**Re: Docket No. SEC 2008-02 - Application of Tennessee Gas Pipeline Company
For a Certificate of Site and Facility Concord Lateral Expansion Project**

Enclosed for filing on behalf of Tennessee Gas Pipeline Company (the "Company") is a copy of the Company's Response to Alteration of Terrain Permit Comments. These are the materials referenced in Attorney Michael Iacopino's Report of Pre-Hearing Conference (issued August 26, 2008) at page 2.

RE: Response to Alteration of Terrain Permit Comments – Permit # 080422-05

ENTRANCE ROAD PLAN AND PROFILE
COMPRESSOR STATION PROJECT
PELHAM, NEW HAMPSHIRE

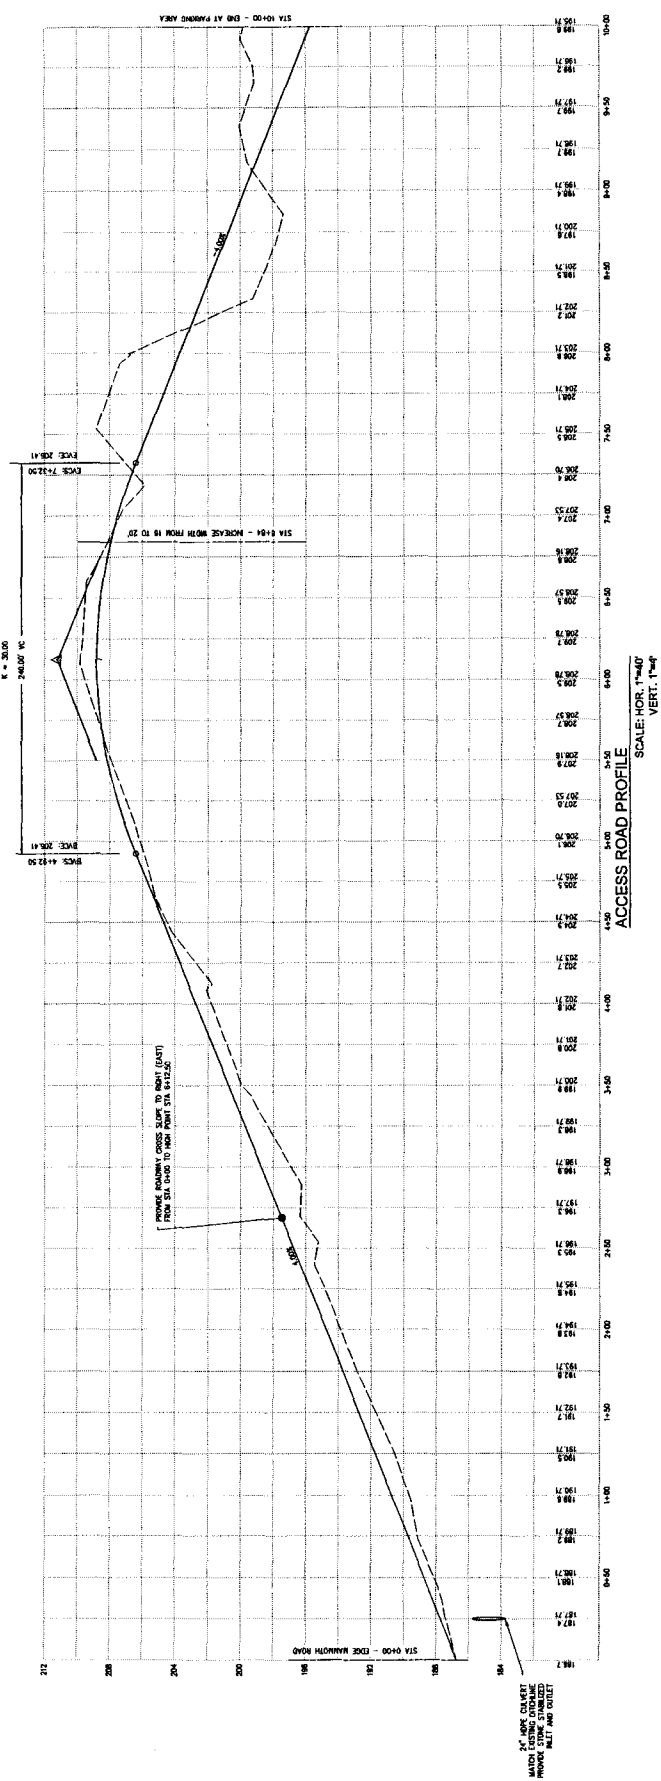
4. *Please provide treatment for the roadway runoff from station 6+00 to the intersection with Industrial Park Drive. Stone check dams are not acceptable for adequate treatment as required by Ws 415.12 Permanent Methods for Protecting Water Quality.*

The design has been revised to incorporate the use of the roadside swale to provide adequate treatment in conformance with Ws 415.12. As described in the Project Description section of the Stormwater Management Summary, the project site is accessed via a 50-foot wide corridor containing an existing gravel road as well as an underground gas pipeline and water main. The applicant does not have land control outside this 50-foot wide corridor. As proposed, the existing gravel drive will be upgraded to pavement as part of the project. The improved road will generally follow the grades of the existing gravel drive sloping upward from Industrial Park Drive to Station 6+12.5. As noted, the previous design included check dams within the roadside swales to provide for some stormwater retention and treatment. To provide for additional treatment the road design has been revised to replace a crowned roadway with one using a consistent cross slope to the right (east) from STA 0+00 to 6+12.5. This will consolidate all roadway runoff in the roadside swale on the right side of the road. No swale will be provided on the left. This will eliminate the need to excavate a swale over the existing natural gas line that parallels the road. We have added Reach 2R1 to the Hydrocad model to analyze the flow conditions within the swale. The swale has been designed with a 2% grade from Station 1+50 to the intersection with Industrial Park Drive so that the flow conditions within the swale meet the maximum velocity and flow rate criteria for treatment swales outlined in Ws 415.12. Additional documentation and supporting hydrocad output is provided in the revised Stormwater Management Report. Sheet 2.0 has been revised accordingly.

PRE-DEVELOPMENT WATERSHED

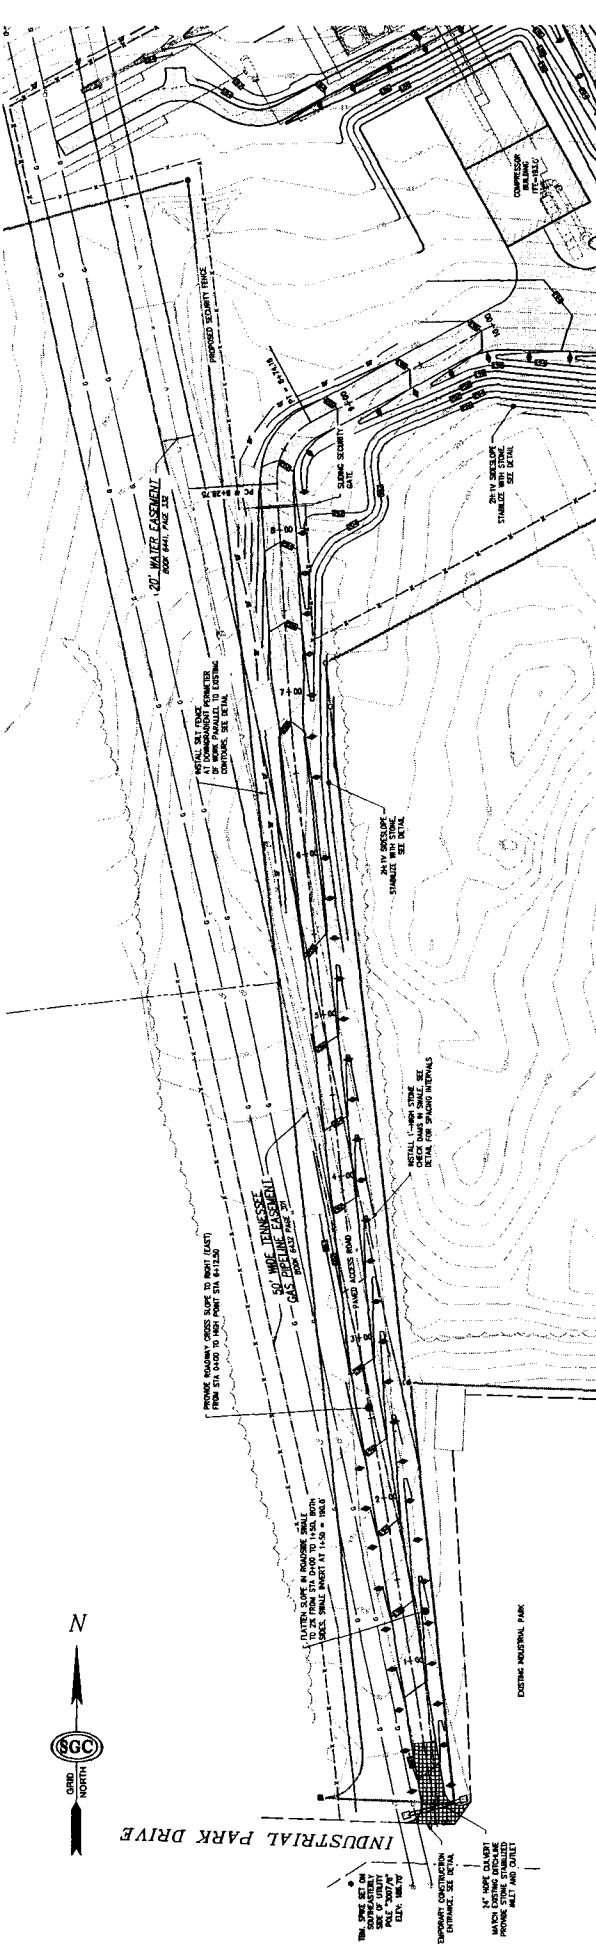
1. *Currently many of the post-development subcatchments are not hydrogeologically homogenous throughout and therefore should not be combined as one subcatchment. Please further subdivide such that the CN value used represents the land use, soils, and cover distributed uniformly throughout the subcatchment.*

The TR-55 stormwater modeling method allows for the use of a weighted curve number to account for a variety of surface types in a watershed. This is necessary in those instances where the flow pattern would otherwise require an overly cumbersome segregation of watersheds and complicated analysis. However, to address your concern further refinement of the watersheds has been completed where practical. As described in the Stormwater Management Report, the property has two distinct drainage sheds - Watershed 1S (tributary to Beaver Brook) and Watershed 2S (tributary to Industrial Park Road). For the Post-Development condition, Watershed 1S was subdivided into smaller watersheds 1S1, 1S2, and 1S3. Watersheds 1S1 and 1S2 represent the developed portion of the site tributary to Ponds 1P1 and 1P2 respectively. Watershed 1S3 represents what will remain the undeveloped portion of the watershed.

Watershed 1S1 is comprised of both undeveloped and impervious land cover and has been further subdivided for this revised analysis. The impervious surface includes of
